November 30, 2023

RE: Public Comments Yellowjacket Project Revised Environmental Assessment

Figure 1: Response line analysis by Grant et al. 2008, based on numerous studies on the effects of timber harvests on peak flows. Orange points mark the mean and max change in peak flow for 85% canopy removal. Red points mark the mean and max change in peak flow for 70% canopy removal.

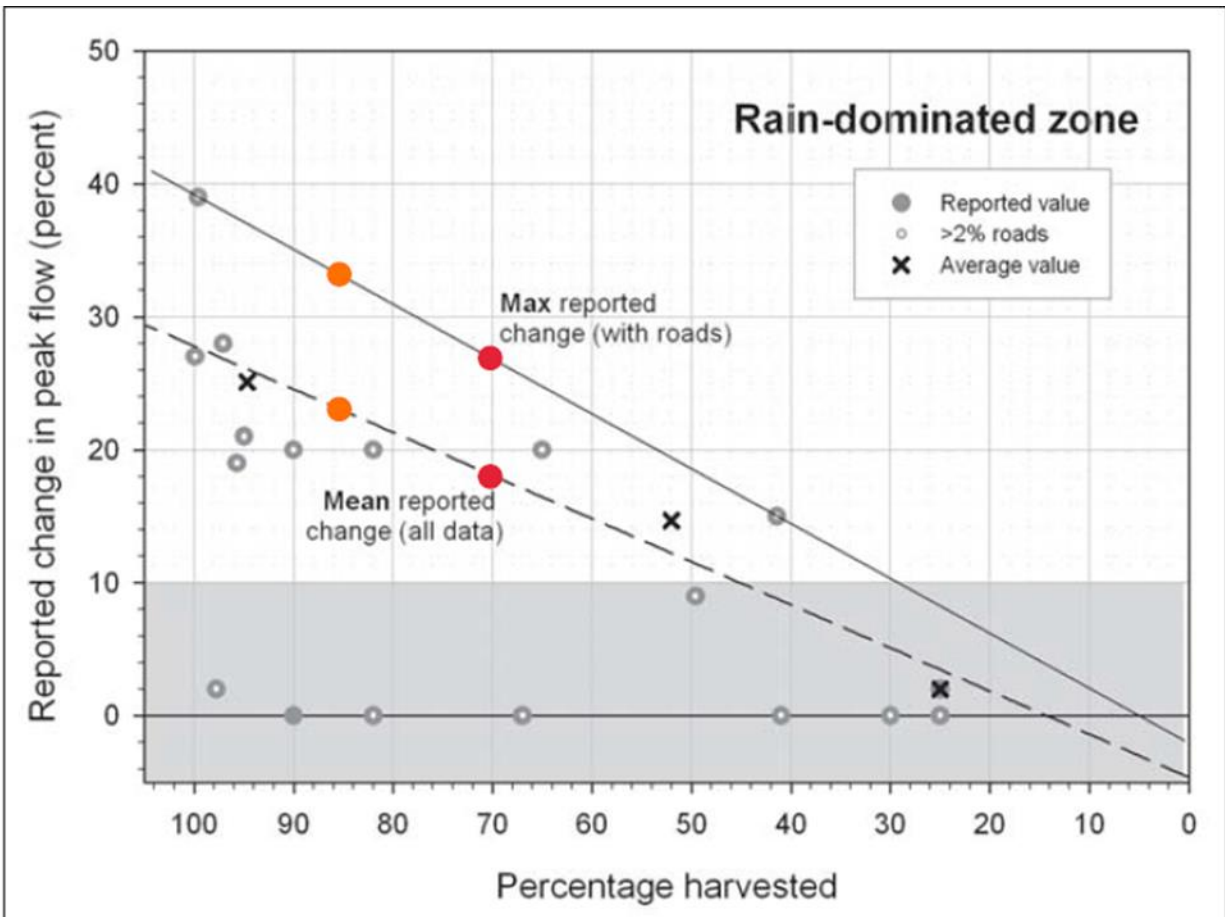
First, the hydrologic specialist report analyzes impacts at a scale that is far too large, failing to consider site-specific impacts as required under NEPA. For example, Stepladder Creek is mentioned in the hydrologic report briefly, but impacts to this drainage are not truly analyzed even though at least 453 acres of its 678 acres are proposed for high-intensity logging (including regeneration harvest, huckleberry enhancement, and high-intensity thin). That means 67% of the entire drainage is slated to be thinned to canopy cover ranges under 40%. Grant et al. (2008) peak flow response analysis at the site-scale predicts that peak flows will increase in rain-dominated zones (<1000 ft elevation) if more than 45% of the canopy is removed from the site. Using their response line model, the mean and max response lines (see Figure 1 -excerpt from Grant et al. 2008) show that in rain-dominated zones (of which Stepladder Creek is a part), when 70% of the canopy is harvested (lower end canopy removal for huckleberry thin), the increase in peak flows could be anywhere between 18-27%. For stands that have 85% harvested (higher end of canopy removal for huckleberry thin and average removal for regeneration harvests), the percent change in peak flows could be anywhere between 23-33%. This trend (i.e., more canopy removed = more change to peak flows) is similar to a global data set for peak flow increases attributed to forest harvest previously analyzed by Guillemette et al. in 2005.³⁶

the drainage level, including hydrologic analysis and examine impacts to fisheries and water quality, for the EA to be in compliance with NEPA. Although the Revised EA acknowledges, “[a]reas thinned to a canopy closure of less than 40 percent are considered hydrologically immature and therefore would potentially contribute to increased runoff . . .”³⁸ due to the scale of the analysis it concludes “[t]he limited number of treatment units with less than 40% canopy cover show little risk of overall change to peak flows at the subwatershed scale.”³⁹ This conclusion seems questionable when 38% of all units (37 out of 131 units) proposed for treatment are proposed to lower the canopy to 40% or below. This is not a “limited number,” and second, this analysis fails to consider cumulative impacts from multiple intensive treatments in smaller, connected drainages and how that might impact water quality and fisheries. For example, as noted above in the Stepladder Creek drainage, it appears that everything but the Riparian Reserves will be impacted by a very intensive and large logging prescription (as shown in Figure 2 attached). The cumulative impacts on water quality and fisheries in this area are likely significant, and the Revised EA should have analyzed impacts at this scale to allow the public to weigh in on the true impacts of the proposal. CFC only pieced together the possible scale of impacts to Stepladder Creek by noting a small mention in the hydrology report and GIS examination, not the Revised EA. Conducting the analysis at the 5th field watershed scale creates “ambiguity” in the Revised EA and hydrology report and prevents the public from providing meaningful feedback on the proposed harvest and alternatives in this area in violation of NEPA.⁴⁰ Additionally, Grant et al. (2008) note, “small watershed studies represent the best and in many cases only means of quantifying the effects of forest practices on streamflow, particularly when combined with modeling or field-based process studies.”⁴¹

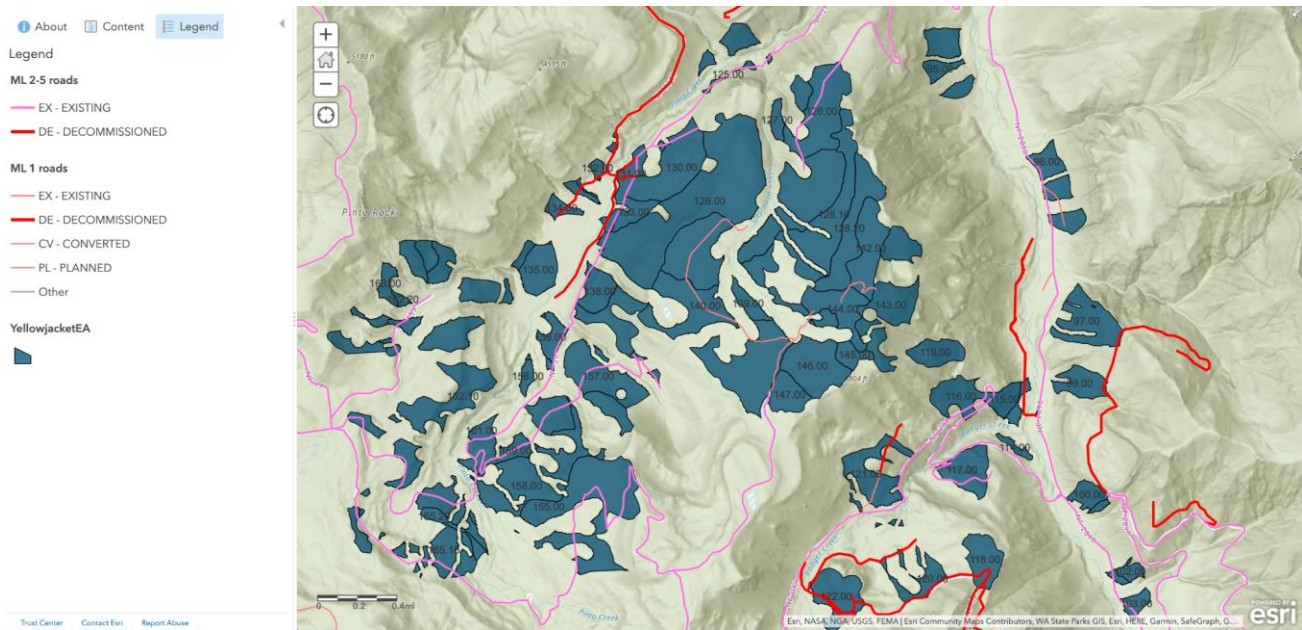
The hydrology report and Revised EA do not look at peak flows or sediment delivery at the site scale³⁷ (which would be Stepladder Creek and/or Pinto Creek) but instead roll its impacts into a larger watershed, diluting the true impacts of the project. The FS must do site-specific analysis at

Finally, many of the huckleberry treatments in the Pinto Creek drainage, particularly around Stepladder Creek, may be hard to access. The area is steep and remote. Given all of the likely negative impacts to water quality, the Forest Service may determine that these areas do not make sense for huckleberry enhancement - which in this land allocation requires there to be a recreational purpose to the treatment.

In sum, CFC requests that the agency 1) supplies a sufficient analysis within the specialist reports, 2) updates the Revised EA to include site-specific water quality and hydrology impacts - including temporary road impacts at the site-specific scale, 3) reduce the spread and intensity of logging in the Stepladder Creek drainage, 4) drops some of the units stemming from the 2810 road (051 and 052 roads) to lessen impacts to waterways - in particular to Yellowjacket Creek, and 5) ensure that the expected degradation from logging and road construction do not violate the Clean Water Act.

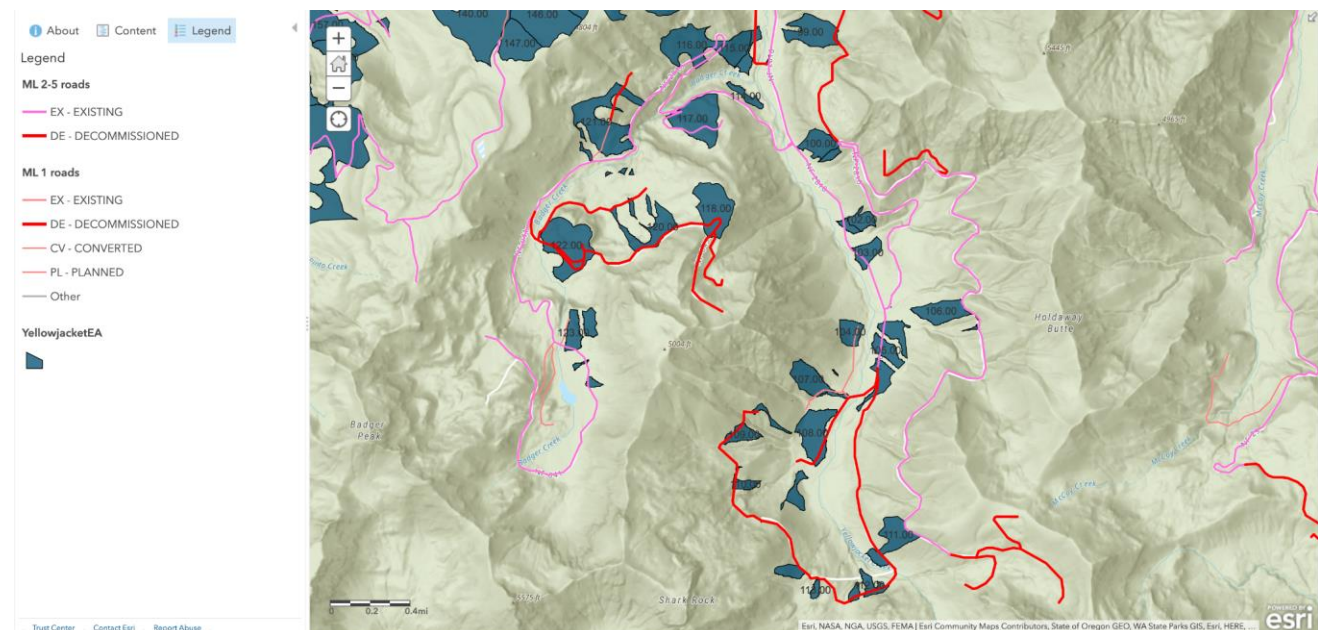
Of particular concern to CFC is the potential use of decommissioned forest roads 051 and 052, stemming from 2810 road (as shown in Figure 3 attached). These roads would cross several tributaries and the mainstem of Yellowjacket Creek, exacerbating temperature and sedimentation issues. Given the impaired history of this waterway, a temporary road system that crosses at least six waterways in a relatively close area is problematic. This issue also illustrates the problems with the water quality analysis and hydrologic analysis in the Revised EA. The potential impacts to Yellowjacket Creek in the area depicted below in Figure 3 are not analyzed at the site-specific scale, which means the current analysis does not constitute a “hard look” under NEPA and does not provide the public with the ability to provide meaningful feedback on the alternatives. Although these decommissioned roads would be temporary in nature, they will likely remain open for multiple years and through winter and spring flows, when serious issues can arise from washouts and general sediment delivery. Additionally, the Forest Service has the data and information, particularly with regard to Yellowjacket Creek, to conduct site-specific analysis as required to pass the “hard look” test.
